Access Compliance Report

Public Rights-of-Way (Curb Ramps)

Intersection ID: 10040847	Main Street: WAKEFIELD_DR	Cross Street: N/A	Location: SE
ADA ID: 7ED061BE28F1	Ramp Type: PerpDiag	Initial Pass/Fail: Fail	Overall Compliance: No
Severity Score: 33.75			
Codes/Mitigation Info/Possible Solution		Field Measurements/Component Compliance

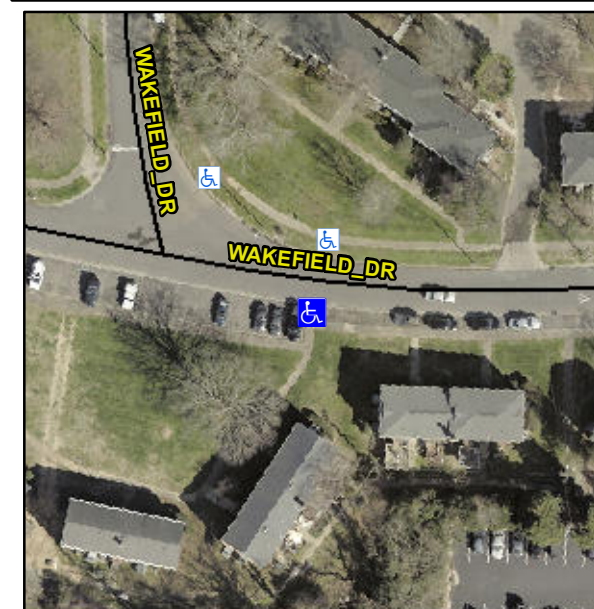
Not Found, R304.5.1, R304.2.2, R304.5.3

Compliance	Description	Data	Compliance	Description	Data
N/A	Ramp Length (in)	125.0	No	Ramp Slope (%)	8.9
No	Ramp Width (in)	47.0	No	Ramp XSlope (%)	6.4
N/A	Flare Type LT	N/A	N/A	Flare Type RT	N/A
N/A	Flare Slope LT (%)	N/A	N/A	Flare Slope RT (%)	N/A
N/A	Flare Traversable LT?	N/A	N/A	Flare Traversable RT?	N/A
N/A	Landing Length (in)	N/A	N/A	DWS Provided?	N/A
N/A	Landing Width (in)	N/A	N/A	DWS Contrast?	N/A
N/A	Landing Slope (%)	N/A	N/A	DWS Length (in)	N/A
N/A	Landing X Slope (%)	N/A	N/A	DWS Full Width?	N/A
N/A	Landing Curb? (Y/N)	N/A	N/A	DWS Offset (in)	N/A
N/A	Shared Landing?	N/A			
N/A	Gutter Ponding?	N/A	N/A	Gutter Slope (%)	N/A
N/A	Gutter Lip Ht (in)	N/A	N/A	Gutter X Slope (%)	N/A
N/A	Painted X Walk1?	No	N/A	Painted X Walk2?	No
	X Walk 1 Direction	To N		X Walk 2 Direction	To W
N/A	X Walk 1 Width (in)	N/A	N/A	X Walk 2 Width (in)	N/A
	X Walk 1 Slope (%)	5.6		X Walk 2 Slope (%)	8.0
	X Walk 1 X Slope (%)	7.0		X Walk 2 X Slope (%)	4.7

N/A	Ramp inside XWalk1?	N/A	N/A	Ramp inside XWalk2?	N/A
	Road Slope (%)	5.4	N/A	Clear Space?	N/A
	Road X Slope (%)	3.4	N/A	Clear Space to XWalk (in)	N/A
N/A	Any Obstructions?	N/A	N/A	Storm Grate/Utility Hazard?	N/A
	Obstruction Type			Storm Grate/Utility Type	
		N/A			N/A
			Yes	Surface Condition? (G/P)	Good

Remove & Replace Curb Ramp With Two New Directional Ramps or Equivalent.
